ISMP Notifications/Work Plans (ECSD) and Approvals Summary Sheet			
Submittal	**Date**	**Agency Approval**	**Approval Date**
ISMP Notification/Work Plan - Shotput and Discus Area	11/4/2022	Approved with Contingencies	11/11/2022
ISMP Notification/Work Plan Addendum #1 - Shotput and Discus Area	4/21/2023	Approval as Modified	4/26/2023
ISMP Notification/Work Plan Addendum #2 - Shotput and Discus Area	6/15/2023	Approval as Modified	7/3/2023
ISMP Notification/Work Plan Addendum #7 - Baseball Field Scoreboard	12/9/2022	Approved with Contingencies	12/14/2022
ISMP Notification/Work Plan - Addendum #8 - ECSD Fence Installation	6/2/2023	Approval as Modified	6/14/2023
ISMP Notification/Work Plan - Excavation of Native Soils during NAF Restoration	6/30/2023	Approval as Modified	7/20/2023
ISMP Notification/Work Plan - Augering of Native Soils during NAF Restoration	6/30/2023	Approval as Modified	7/20/2023
ISMP Notification/Work Plan - Softball Field Perimeter Fence Drain Corrective Measures	3/1/2024	Approved	3/13/2024

Subject: RE: NYSDEC #c808022 - ISMP Notification for ECSD Shotput Discus Area

The Agency has reviewed the ISMP Notification for ECSD Shotput Discus Area dated November 4, 2022 f

SITE IMPROVEMENT PLAN

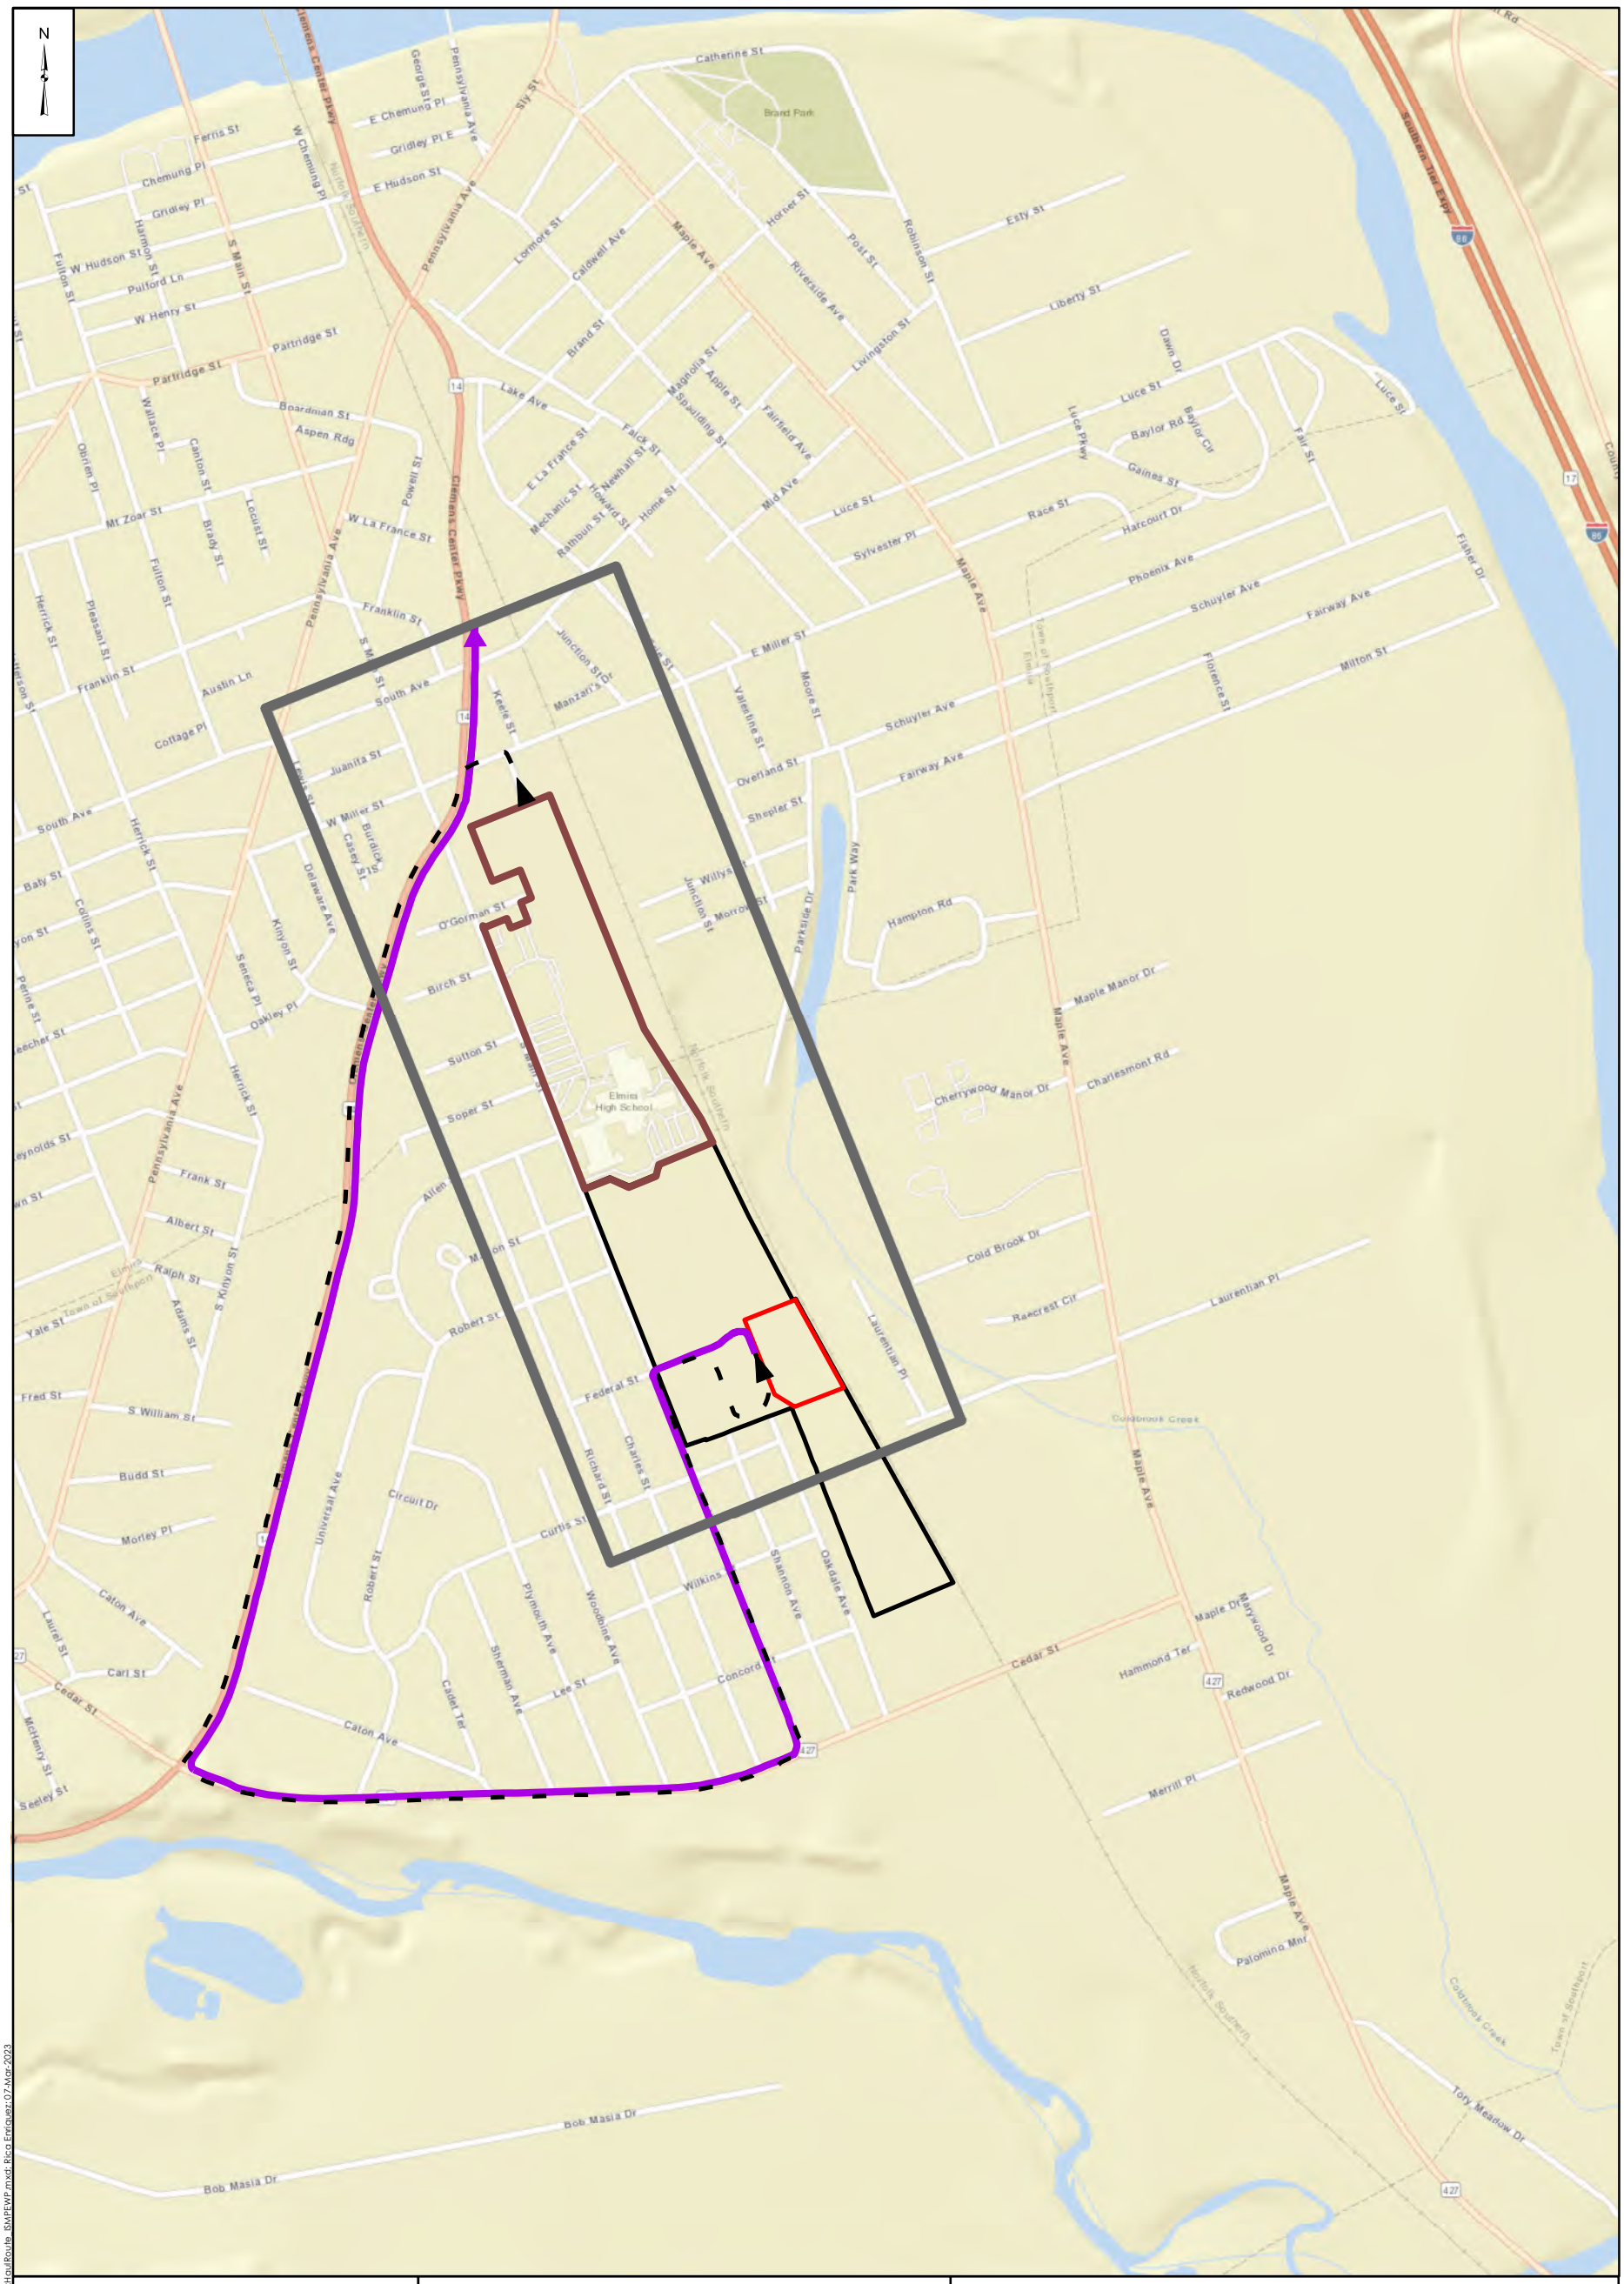
2. The Work Plan only addresses the installation of two fence posts; however, all fence post installations within the Shotput-Discus Area shown on Appendix A – Site Improvement Plan are subject to QEP oversight to ensure the proper handling and management of soils where native materials are encountered.
